CLARK COUNTY, NEVADA BID NO. 603836-15 CAMP LEE CANYON COOLER REFURBISHMENT

ADDENDUM NO. 2

ADDENDUM No. 2
CAMP LEE CANYON COOLER REFURBISHMENT

1 IMPROVED PARTIAL SITE PLAN
 SCALE: N.T.S. REF. S1.0 FOR INFO. NOT SHOWN

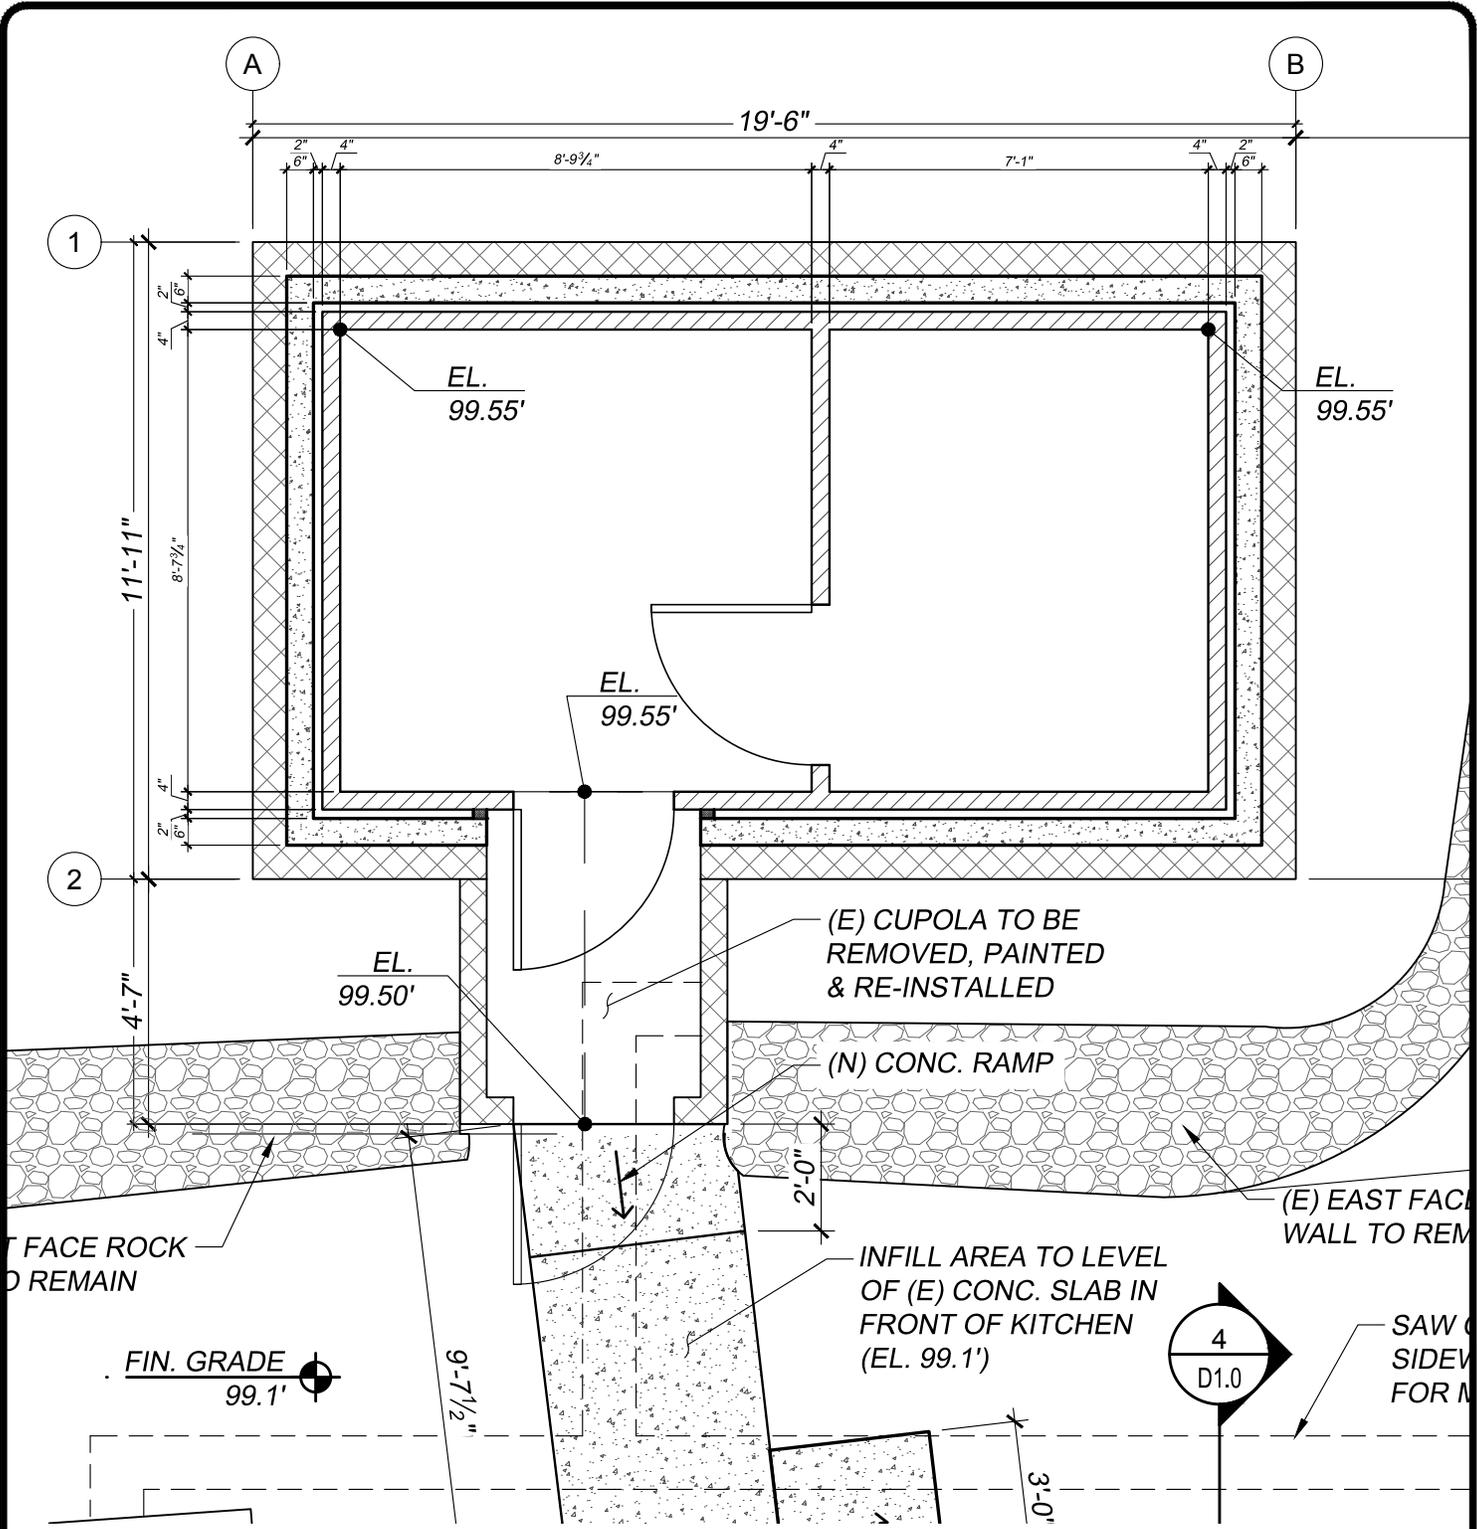
2. SK-1: (See Attachment) – Sheet S1.0, Modify Floor plan 1 “Improved Site Plan” to show changed internal elevations.
3. SK-2: (See Attachment) - Sheet S2.0, Delete Section A, and Replace it with sketch SK-2.

4. QUESTION: “The new floor needs to be poured level for proper installation of the new cooler box / panels. Trying to find a manufacturer that will custom build panels to accommodate a pitched floor will result in excessive lead times. Please confirm that this change can be made.”

ANSWER: Pour concrete floor flat inside cooler and freezer per SK-1 and SK-2 as reflected on Item 4 above. Simplify Walk-In cooler/freezer to fasten to flat concrete floor. Fasten to floor and seal against Walk-In walls per manuf. recommendations. Seal concrete floor as originally specified.
